Discussion Paper - Bradfield City Centre Masterplan Application

Amendments to Western Sydney Aerotropolis Precinct Plan and Development Control Plan.

October 2023

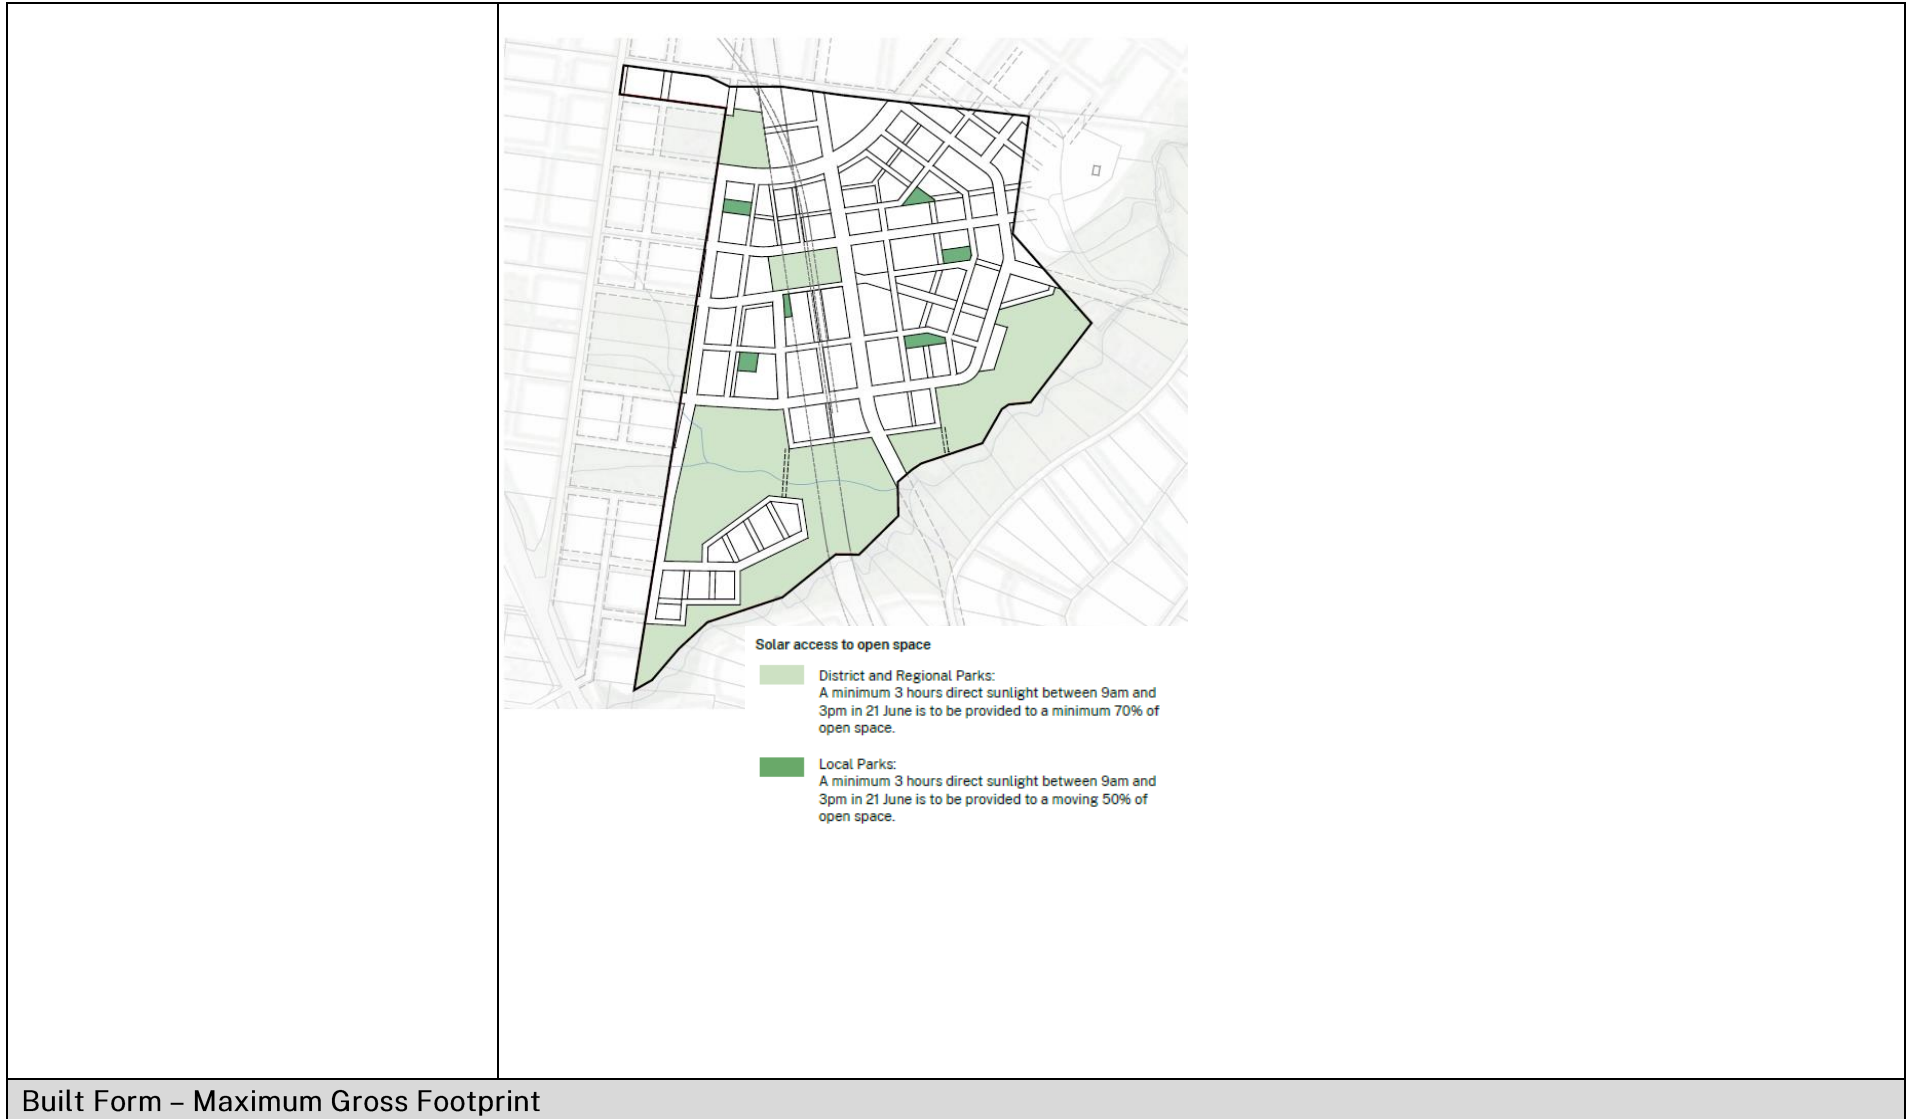
The Master Plan sets out alternative benchmark solutions to building and landscape setbacks and separation controls with more detailed site-specific setbacks for the Bradfield City Centre (refer to image below).

Building setbacks within Bradfield City Centre are to be consistent with the controls outlined in the diagrams on this page.

-  0m setbacks required (3m setback permitted to accommodate outdoor dining and 3m setback required for any ground floor residential)
-  3m setbacks required to green loop, residential and enterprise areas

<p>The building and ground level street setbacks proposed to the street hierarchy and urban context of the site and make allowances for the provision of tree canopy, deep soil, and landscape zones. Complementary to this, building envelopes have been established and provide appropriate building separation that responds to the site context, building use, orientation, and street network.</p> <p>It is considered that the alternative setback controls provide the necessary setbacks to maximise efficient use of land where amenity in the public domain is not reduced.</p> <p>Solar</p> <p>Clause 4.2.3 (PO2) sets out the solar access provisions that apply to the site, The Master Plan proposes to amend the current solar controls that apply to the site and introduces an additional control which applies to local parks. Presently, the DCP requires in mid-winter a minimum of 3 hrs solar access between 9am and 3pm on the 21st of June to 70% area of open space. This is not achievable for local parks and will significantly restrict density and positive built form outcomes.</p> <p>For this reason, the Master Plan proposes an alternative control for local parks specific to the Bradfield City Centre. The additional control for local parks proposes that they achieve a minimum of 3 hours direct sunlight between 9am and 3pm on the 21st of June to a moving 50% area of open space.</p>

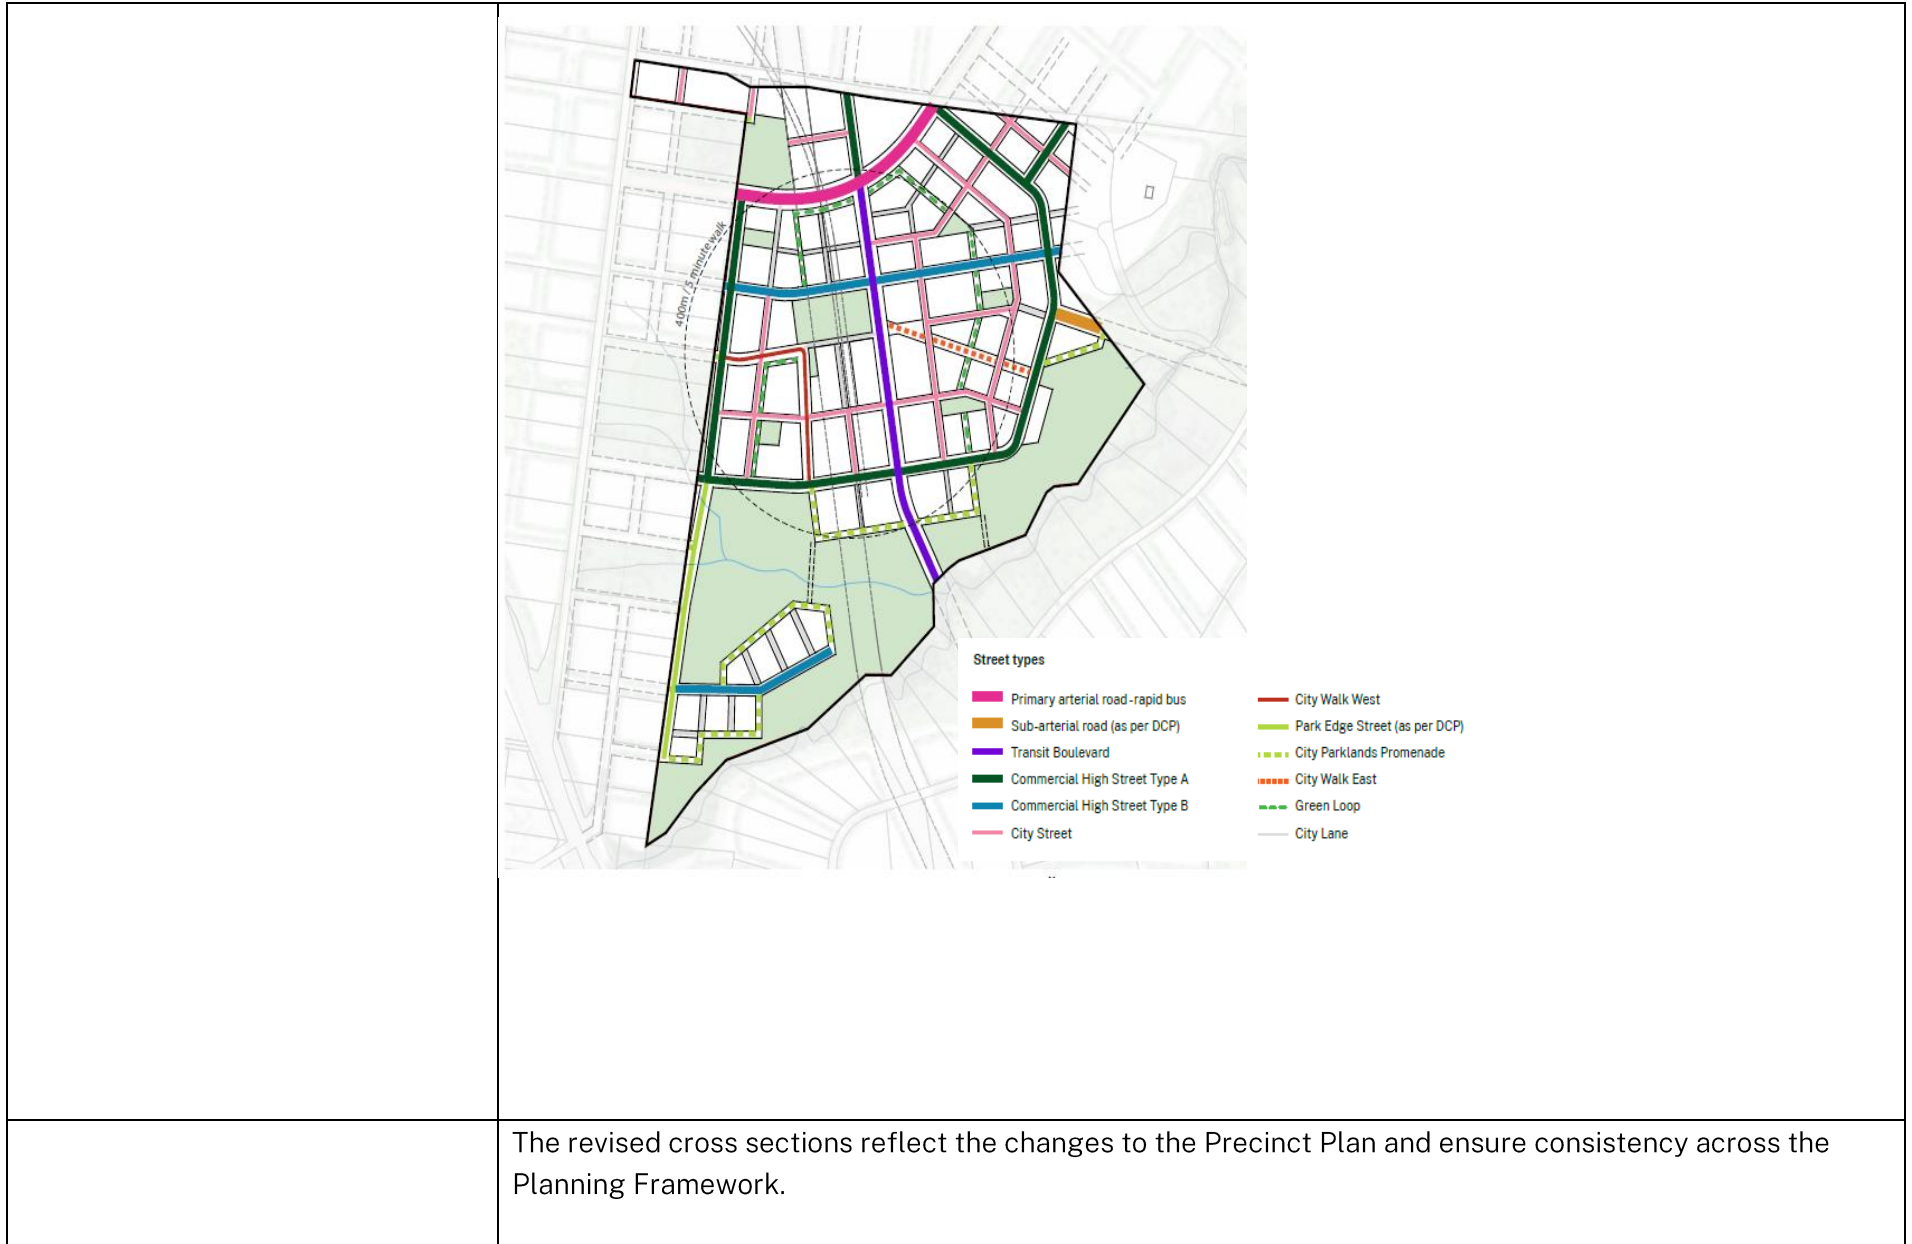
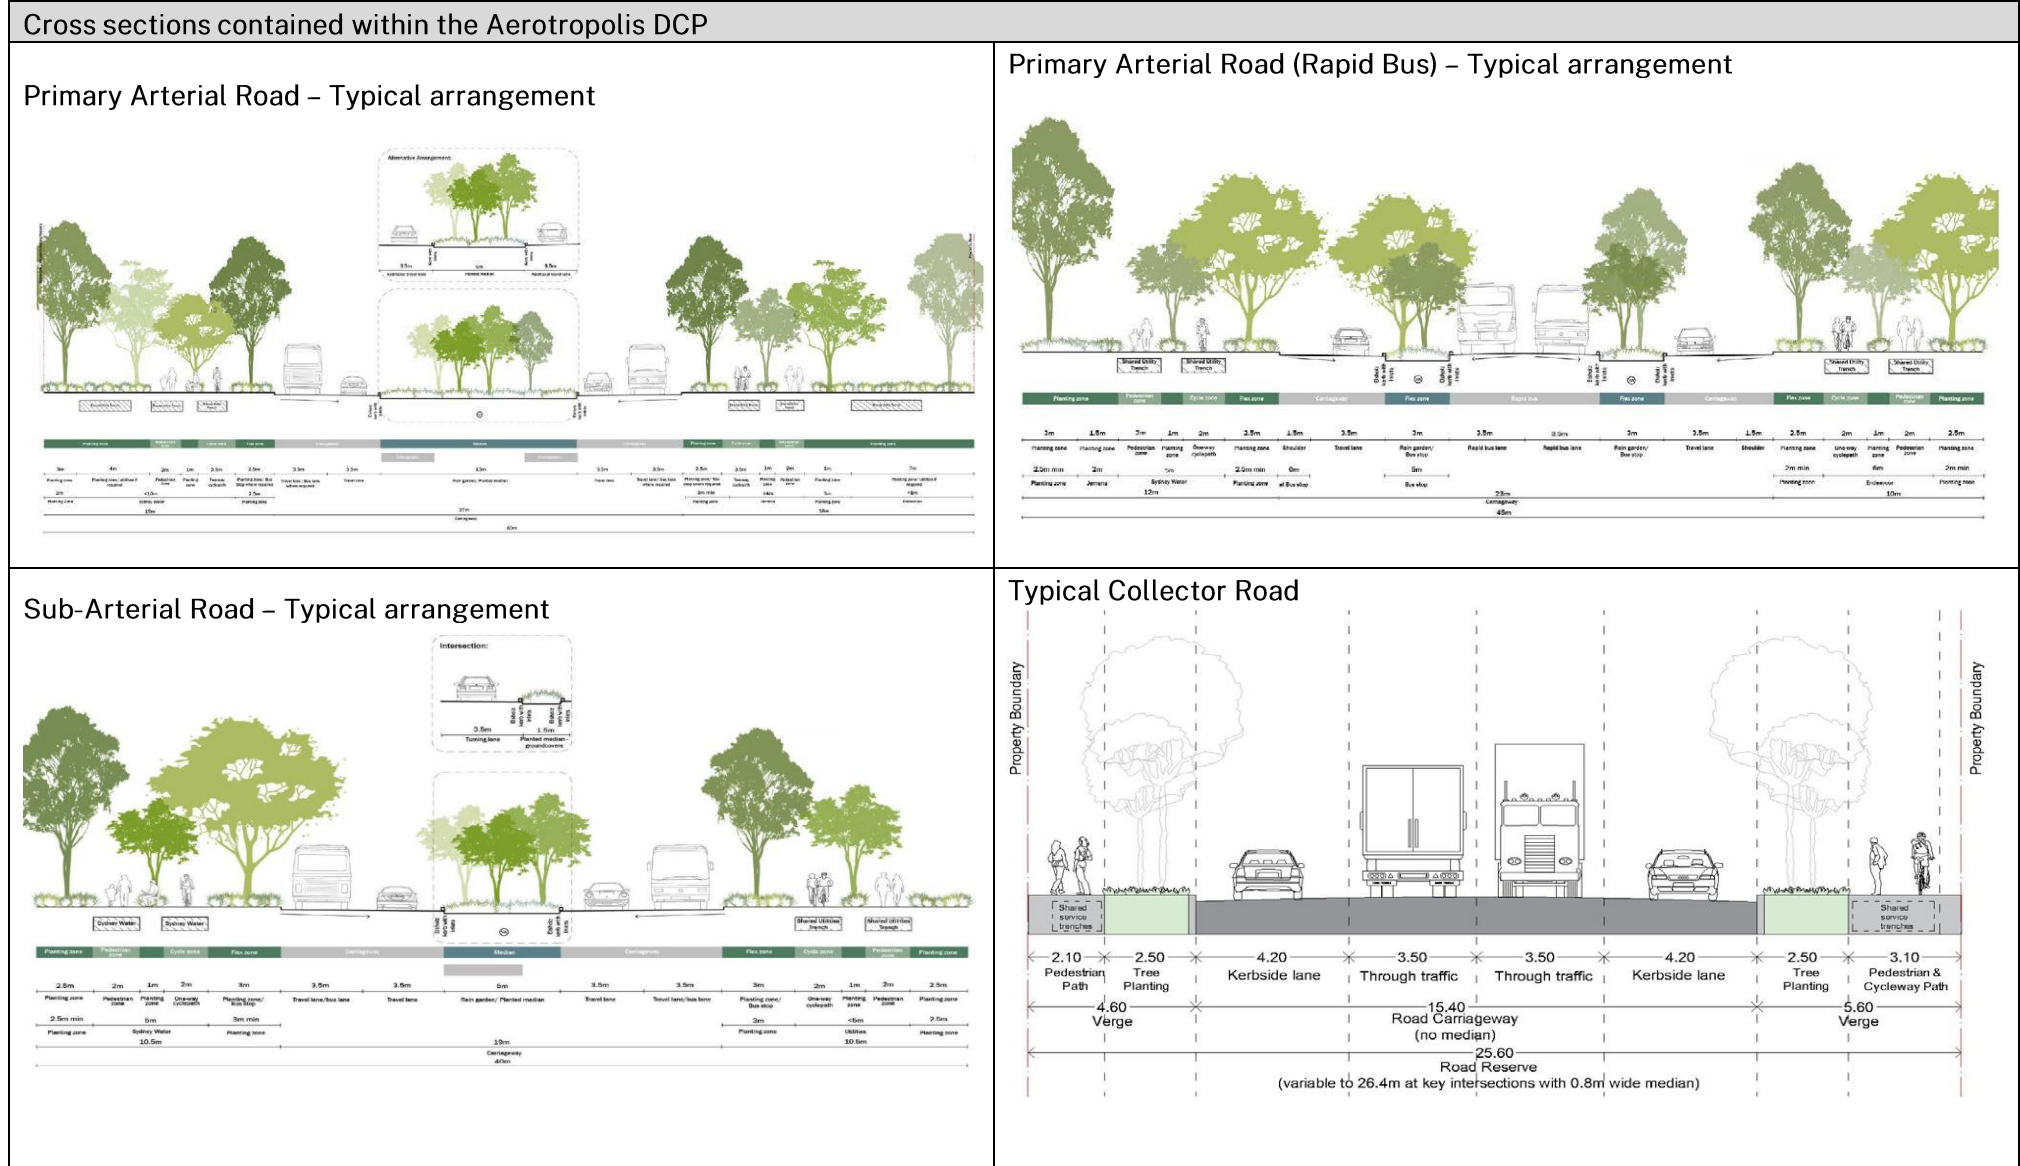
In summary the proposed amendments to the Street Hierarchy Plan include:

- Amendments to the street network in line with the Master Plan design.
- Identify pedestrian-only and shared zone street types (City Lanes and Parklands Promenade).
- Provide direct connections from Central Park to Moore Gully and Thompsons Creek activity nodes.
- Amend the collector roads more direct connection between Whitaker Road and Metro Link Boulevard.
- Identify pedestrian connections across Moore Gully and Thompsons Creek regional park.
- Realigned the bridge over Thompsons Creek to the east slightly.
- Realigned Whitaker Road slightly.

As a result of these amendments, the cross sections contained within the Aerotropolis DCP will not apply to the Bradfield City Centre site and are replaced by the cross sections detailed below.

Overall, the amendments allow for a finer grain structure that prioritises pedestrian movement and promotes more sustainable and healthy transport choices. In addition, the amendments enable more direct convenient access between key destinations and activity nodes and facilitate the improved delivery of transport infrastructure by providing a more connected transport network.
